# Addendum Report

## Updated Planning Statement – Brinsham West Quarry Access Road

### Heidelberg Materials UK Ltd (previously Hanson)

SLR Project No.: 425.065060.00001

**Plates 1-3 – Comparison diagrams showing the reduction in physical infrastructure between the Brinsham West current permitted scheme and the proposed temporary haul road**

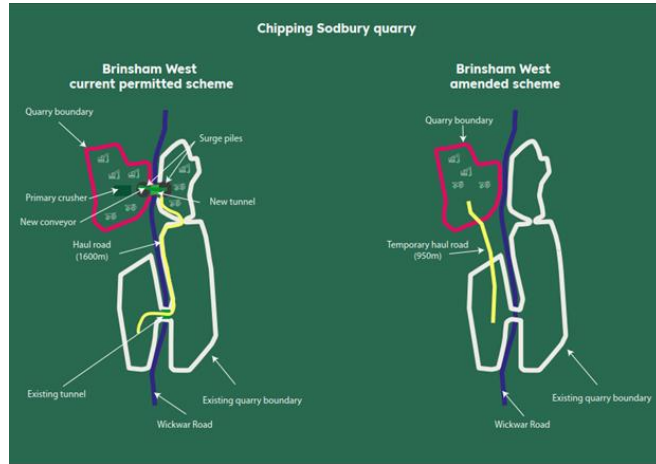
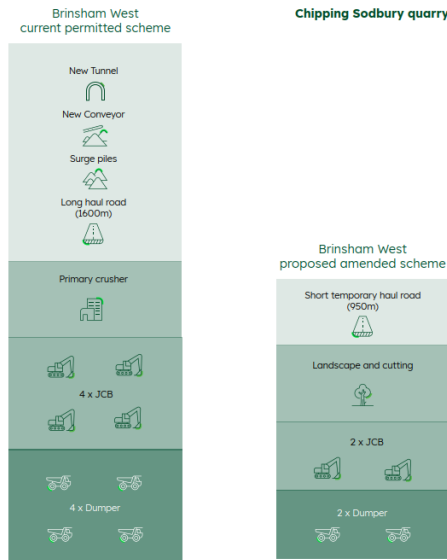
**Plates 1-3** below show the comparison between the permitted Brinsham West scheme (on the left) and the proposed temporary haul road on the right, with the Quarry shown outlined in red. In terms of physical infrastructure:

- the haul road, shown in yellow, for the permitted scheme is 1600m in length and is significantly reduced when compared to the proposed temporary scheme, reducing the length to 950m (a reduction of 30%);

- the reduction in the haul road length will in turn, reduce the distance travelled by haul trucks by almost 150,000 km over the duration of the operational period of Brinsham West Quarry;

- a reduction in distance travelled will further reduce any noise or emission impacts associated with vehicles travelling to and from Brinsham West to Southfields;

- the tunnel and conveyor are shown as light green on the permitted scheme. The construction of the tunnel under Wickwar Road will present significant environmental impacts and would be a permanent feature in the landscape. The impacts of the tunnel construction are likely to be significant (noise/vibration etc) as well as presenting a temporary road closure and diversion of traffic.

- by implementing the proposed temporary haul road scheme, any temporary environmental impacts can be mitigated against (as presented in the accompanying appendices), with full restoration of this area upon completion of Brinsham West;

- the removal of primary crusher and surge piles of limestone shown on the current permitted scheme (in dark green and grey), will represent a significant reduction in any operational activity associated with those activities in Brinsham West, with extracted material travelling directly to the existing and established processing area in Southfields
